Sent: 9/09/2019 12:50:08 PM
Subject: submission re DA2019/0884 - 51 Redman Road
Attachments: Submission re DA2019 0884 51 Redman Road.pdf;

Re: DA 2019/0884 51 Redman Road Dee Why

Figure 2: Window locations of Units 4 (L1) and 8 (L2) in relation to bulk of main dwelling

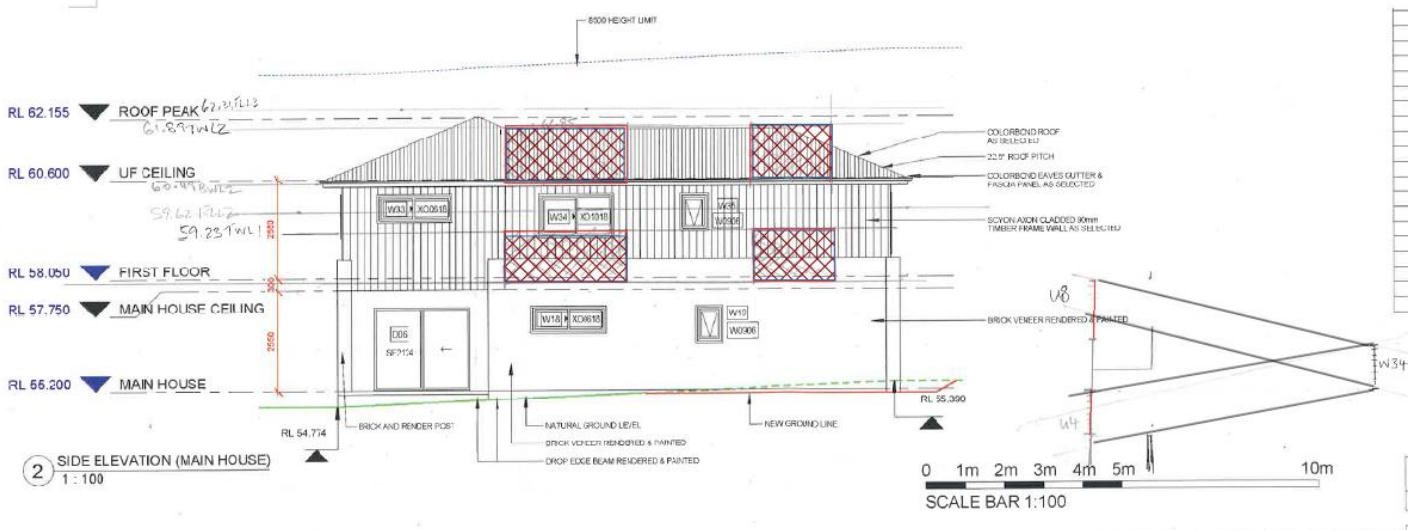
Given the height of the main dwelling, this is a particularly significant impact for Unit 4 (Level 1) and Unit 8 (Level 2). As demonstrated in Figure 2 below, by extrapolating the levels supplied in the site plan on Sheet A03 of the supplied plans and superimposing the window locations of these units (in red) onto Side Elevation 2 (which faces 53 Redman Road) on Sheet A11, the side of the main dwelling will not only dominate, but will in fact encompass the entire view available.

Referring again to Figure 2 above, drawn from Side Elevation 2 on Sheet A11 of the supplied plans and depicting the location of the windows of Units 4 and 8 in relation to the proposed main dwelling, Window W34, associated with Bedroom 3 of the proposed main dwelling, is centred within the same vertical alignment as the lounge windows (and corresponding balconies) of Units 4 and 8. This allows W34 to look down upon the private open space (balcony) and the lounge room window of Unit 4 from a distance of 5.4m and 7m respectively. Conversely, it also allows Unit 8 to look down into the bedroom associated with W34 from the same distances. The angle of view afforded at these distances represents a significant impact on privacy. This would appear to **fail requirement 4 of Section D8 of the WDCP**.

This visual impact can be completely eliminated by relocation of the 2 storey main dwelling to the front of the block, as is consistent with the local neighbourhood character, where the main bulk of the development will then be located in front of garages only.
